Addendum No. 01

Project #: 25-063
Project Name: Western Financial Place
Condenser Replacement

PROJECT TITLE	WESTERN FINANCE PLACE - CONDENSER REPLACEMENT	PROJECT NUMBER	2571
DRAWING TITLE	ACCESS LADDER & PLATFORM	DATE	2026-10-15
		DRAWN BY	NG
		REVISION NUMBER	1
		VERSION	SK1

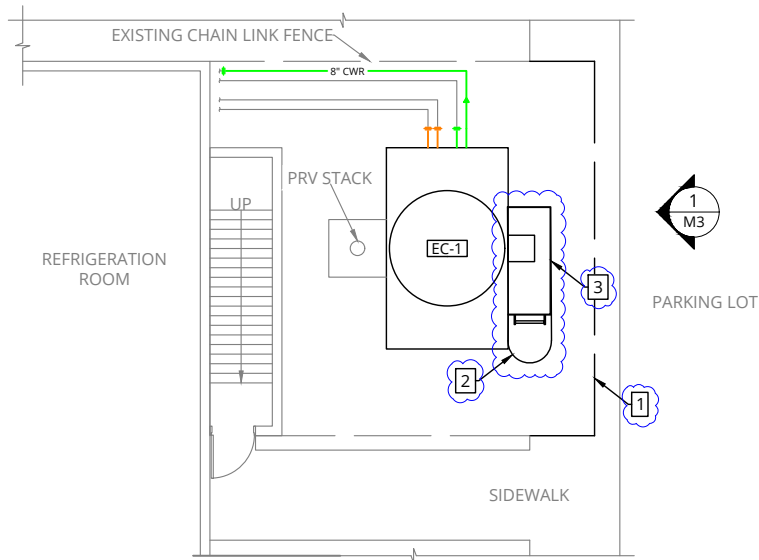
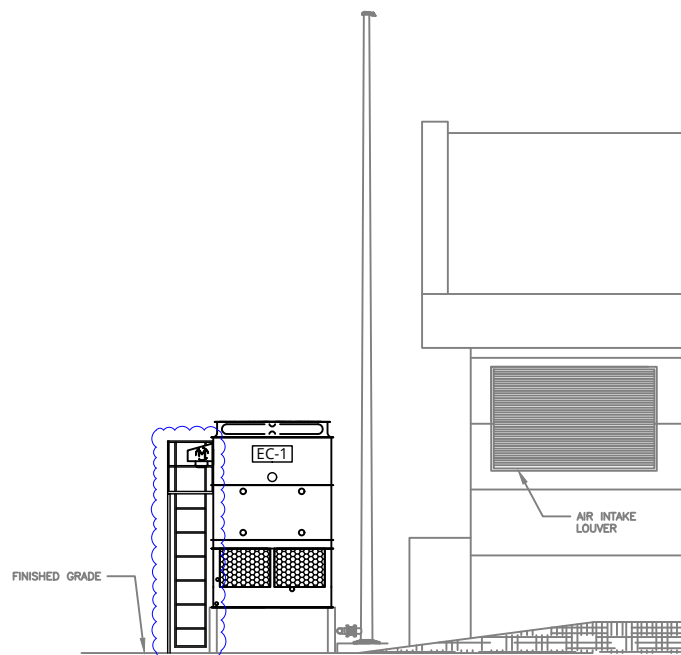
Item 2. Refer to the attached sketch provided by Polar Engineering of the access ladder and platform to be added to the project scope. The fence is already shown to be extended on the architectural tender drawings.

Item 3. Refer to the attached sketch provided by Polar Engineering of the access ladder and platform to be added to the project scope.

3. **Question:** Is a platform and ladder required for the unit?
Response: A ladder and access platform is to be added. Polar has confirmed with the local TSBC inspector that this will have no compliance impacts. **Refer to the attached sketch provided by Polar Engineering of the access ladder and platform to be added to the project scope.**

- KEYNOTES:
1. EXTEND FENCING TO ACCOMMODATE LADDER AND PLATFORM. FOR DETAILS SEE ARCHITECTURAL DRAWINGS.
 2. ENCLOSED ACCESS LADDER
 3. SERVICE PLATFORM
